# Access Compliance Report

## Public Rights-of-Way

### (Curb Ramps)

Intersection ID: 54219	Main Street: SANDY_ROCK_PL	Cross Street: NORTH_REA_PARK_LN	Location: SW
ADA ID: 57D4C296398E	Ramp Type: Perp	Initial Pass/Fail: Fail	Overall Compliance: No
Severity Score: 12.5			
Codes/Mitigation Info/Possible Solution		Field Measurements/Component Compliance

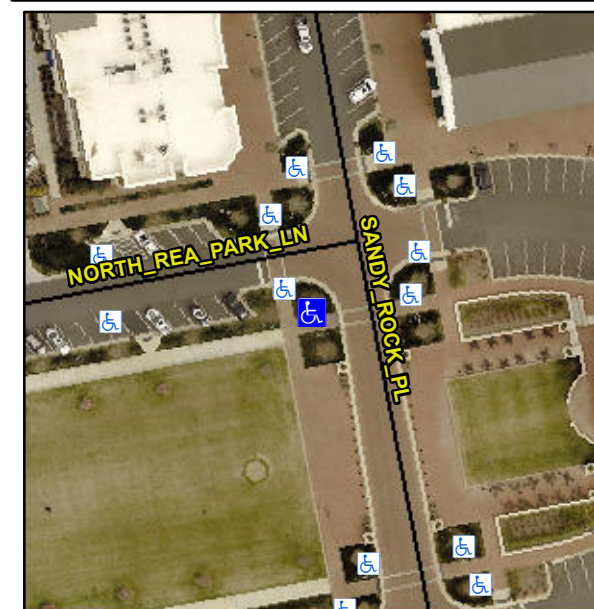
**R304.2.2**

Compliance	Description	Data	Compliance	Description	Data
N/A	Ramp Length (in)	24.0	No	Ramp Slope (%)	8.7
Yes	Ramp Width (in)	96.0	Yes	Ramp XSlope (%)	1.2
N/A	Flare Type LT	N/A	N/A	Flare Type RT	N/A
N/A	Flare Slope LT (%)	N/A	N/A	Flare Slope RT (%)	N/A
N/A	Flare Traversable LT?	N/A	N/A	Flare Traversable RT?	N/A
N/A	Landing Length (in)	N/A	N/A	DWS Provided?	N/A
N/A	Landing Width (in)	N/A	N/A	DWS Contrast?	N/A
N/A	Landing Slope (%)	N/A	N/A	DWS Length (in)	N/A
N/A	Landing X Slope (%)	N/A	N/A	DWS Full Width?	N/A
N/A	Landing Curb? (Y/N)	N/A	N/A	DWS Offset (in)	N/A
N/A	Shared Landing?	N/A			
N/A	Gutter Ponding?	N/A	N/A	Gutter Slope (%)	N/A
N/A	Gutter Lip Ht (in)	N/A	N/A	Gutter X Slope (%)	N/A
N/A	Painted X Walk1?	Yes	N/A	Painted X Walk2?	N/A
	X Walk 1 Direction	To E		X Walk 2 Direction	N/A
N/A	X Walk 1 Width (in)	72.0	N/A	X Walk 2 Width (in)	N/A
	X Walk 1 Slope (%)	0.9		X Walk 2 Slope (%)	N/A
	X Walk 1 X Slope (%)	3.3		X Walk 2 X Slope (%)	N/A

**Remove & Replace Entire Ramp.**
